TRANS/WP.29/GRE/2004/5/Rev.1  
19 July 2004

DRAFT PROPOSAL FOR AMENDMENTS TO REGULATION No. 87

(Daytime running lights)

Transmitted by the expert from the Working Party "Brussels 1952" (GTB)

**MINIMUM ANGLES REQUIRED FOR LIGHT DISTRIBUTION IN SPACE**

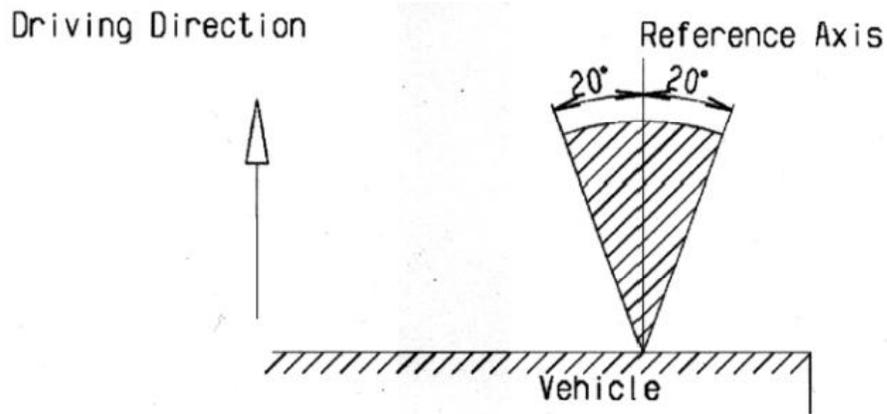
Insert a new annex 7, to read (see next page):

**In all cases, the minimum vertical angles of light distribution in space are 10° above and 5° below the horizontal for DRL devices included in the Regulation.**

**Minimum horizontal angles of light distribution in space:**

Annex 7 has been introduced to define the angles of light distribution in space, in line with other signal lamps regulations.
